Product Change Notification

Date Issued :	March 08, 2023	PCN Number :	513340
Reason for Change :	Equipment Transfer, Production Transfer or Rearrangement		
Description of Change :	Equipment Transfer This notification is to inform you about an equipment transfer that has been used to manufacture impacted parts. Equipment is being moved to a different site location. No changes will be made to product as part of this change		
Assessment of Change :	First Article Inspection		
Planned Implementation Date :	September 08, 2023		
Sample Availability Date:	August 11, 2023		
Internal Molex Qualification Date :	August 25, 2023		
Last date to request Samples by Customer :	August 01, 2023		
Traceability Code Markings / Date :	Factory order number

■ Ultra Fit Headers with Solder Nail attachment

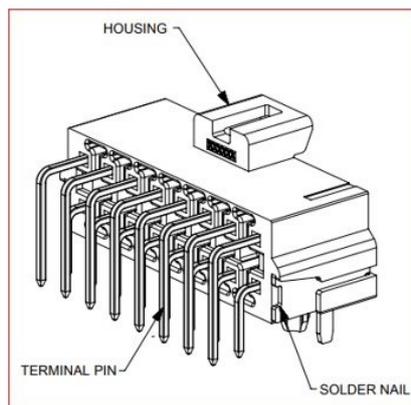
- As a valued customer, we want to notify you that:
 - Molex will relocate the Ultra Fit solder nail component die from Little Rock, AR to our Nogales, Mexico plant where the finished header assemblies are manufactured
 - No changes will be made to metal raw material or source
- Product Impact
 - None, no impact to form, fit or function
- Molex part numbers impacted
 - Series 172310 & 172316, see attached list
- Qualification Reports and samples available for the finished goods available upon request
